World Forum for Harmonization of Vehicle Regulations**Working Party on General Safety Provisions****117th session**

Geneva, 8-11 October 2019

UN Regulation No. 26 (External projections of passenger cars)**Proposal for the 04 series of amendments to UN Regulation
No. 26 (External projection for passenger cars)****Submitted by the expert from France***

Figure 0 - Example of parts distribution

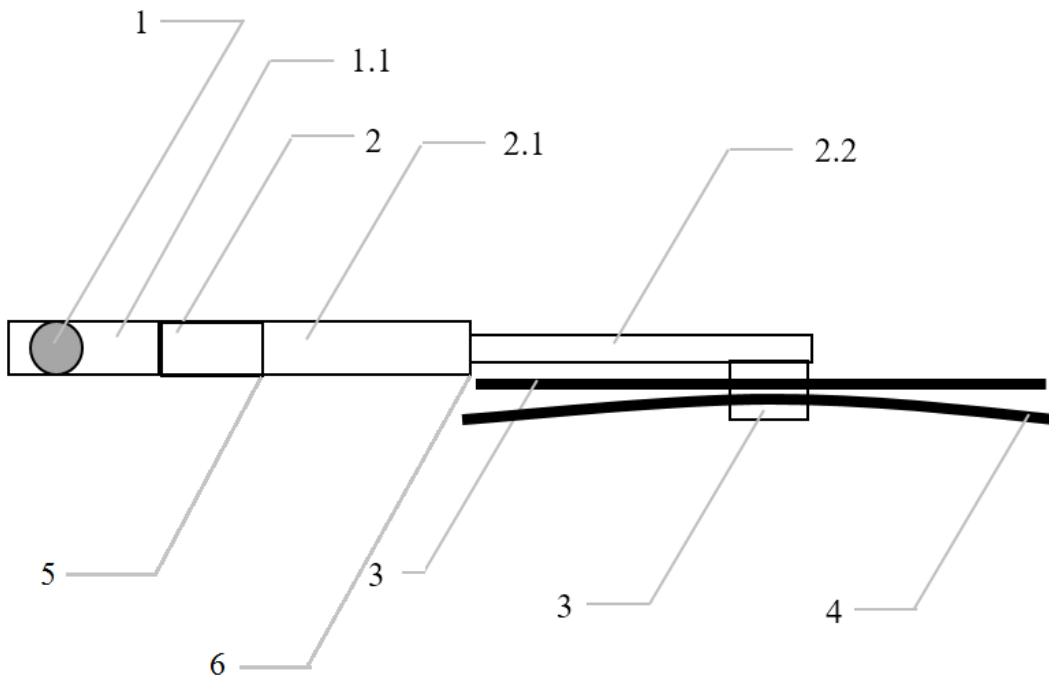
- "6.4. Windscreen wipers
- 6.4.1. The windscreen wiper fittings shall be such that the wiper shaft (**number 1 in Figure 0**) is furnished with a protective casing (**number 1.1 in Figure 0**) which has a radius of curvature meeting the requirements of paragraph 5.4. above and an end surface area of not less than 150 mm². **The holder (head and main part, i.e. numbers 2, 2.1 in Figure 0) are designed with a radius of curvature meeting the requirements of paragraph 5.4. above.** In the case of rounded covers, these shall have a minimum projected area of 150 mm² when measured not more than 6.5 mm from the point projecting furthest. These requirements shall also be met by rear window wipers and headlamp wipers.

- 6.4.2. Paragraph 5.4. shall not apply to the wiper blades (**number 4 in Figure 0**), ~~or~~ to ~~any~~ supporting members (**number 3 in Figure 0**) if present, to second holder (**number 2.2 in Figure 0**) if present, to the functional hinge between the holder head and the holder (**number 5 in Figure 0**) if present, or to the junction between the main and the second holder (**number 6 in Figure 0**) if present. However, these units shall be so made as to have no sharp angles or pointed or cutting parts.

2. In this way, this draft proposal clarifies how to deal with potential "exempted" parts and which requirements apply to which part of the windscreen wiper. A generic drawing presenting the concerned areas seems to be the best way for a coherent application in association with requirement wording.
